SERVICE DIRECTIVE BULLETIN NO. 0064

SUBJECT: Collective Friction Usage

MODELS: F-28A, 280, F-28C, 280C, F-28F and 280F

28-16296-II PLACARD

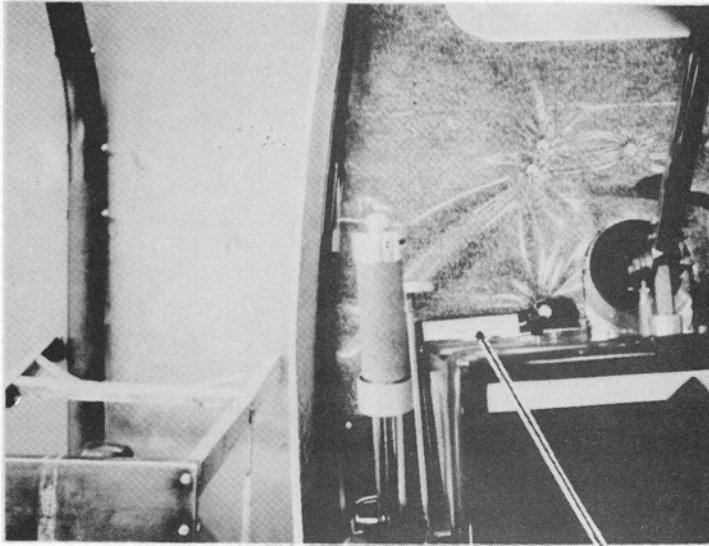
Current production Enstrom helicopters are placarded "COLLECTIVE FRICTION TO BE USED FOR GROUND OPERATION ONLY" on the fiberglass seat flair near the collective friction handle (refer to picture). Included with this bulletin is the placard which must be installed, as shown, on all Enstrom helicopters. Additional decals can be obtained from Enstrom Helicopter Service Department by ordering P/N 28-16296-11.

NOTE: Placard to be positioned even with edge of seat cover and inverted to facilitate reading by pilot.
